From: Zac Denton
Sent: 25 July 2019 09:34
To: Planning Scanning
Subject: FW: Mistletoe Farm, Horsemere Green Lane. CM/13/19/RES; Revised Drainage Proposals
Attachments: ES1820-602-04 B Drainage Strategy with Ditch.pdf; cm1319res tree retention and protection plan.pdf

Subject: Mistletoe Farm, Horsemere Green Lane. CM/13/19/RES; Revised Drainage Proposals

Drawing Title Engineering Details Drainage Strategy (with Ditch)				
Drawn KN	Checked	Scales 1:250	Paper Size A1	Date 07.19
Job No. ES1820	Drawing No. 602-04	Revision B

Tree Retention and Protection Plan
Mistletoe Farm, Horsemere Green Lane, Climping, West Sussex

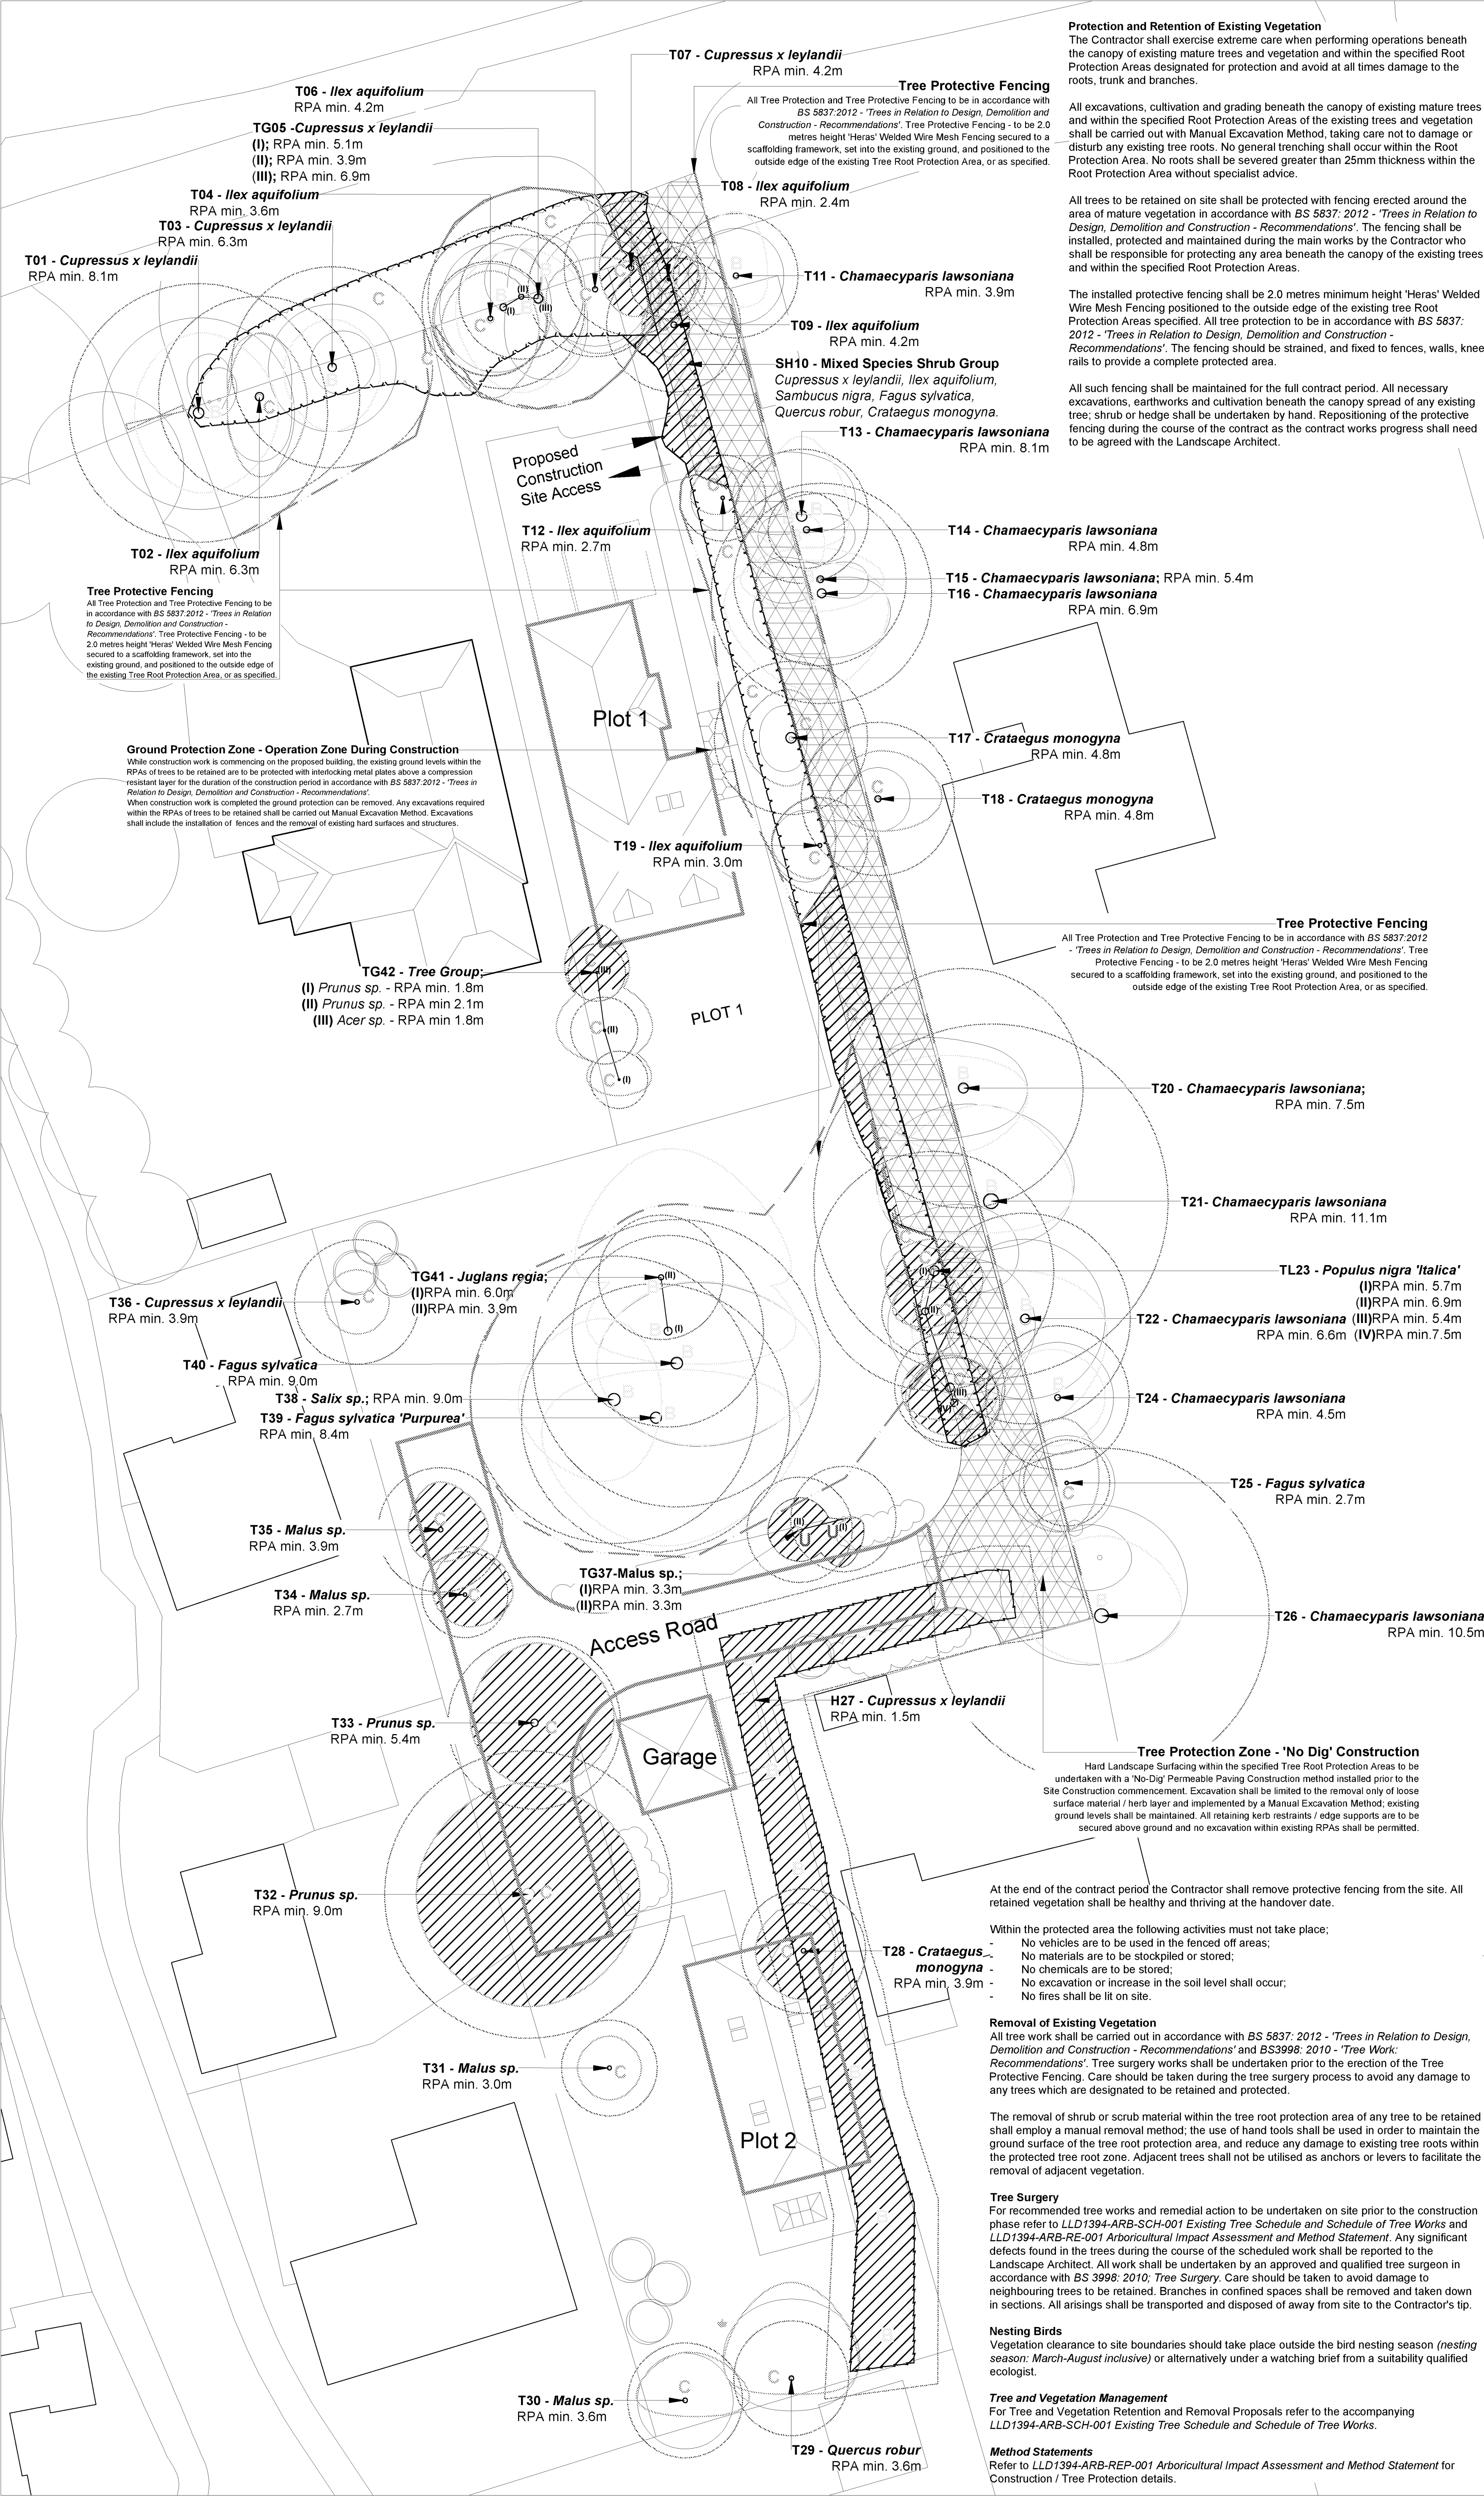
Thank you for sending over the revised plan. I believe there is some conflict between what you are proposing and the tree protection plan (attached).

The permeable paving for plot 2 looks like it could only be located in the T furthest round on the road rather than at the junction of roads 1 and 2. The swale also appears to be within a no dig area.

Thank you for your comments. I was under a misapprehension regarding the RPZ so having cleared that I have put together a revised proposal which addresses your comments on the RPZ. Hopefully you find this revised proposal accords with your thoughts and you are able to advise your planning colleague that we have reached a drainage solution. As always, if you have any further concerns please contact me. Many thanks.
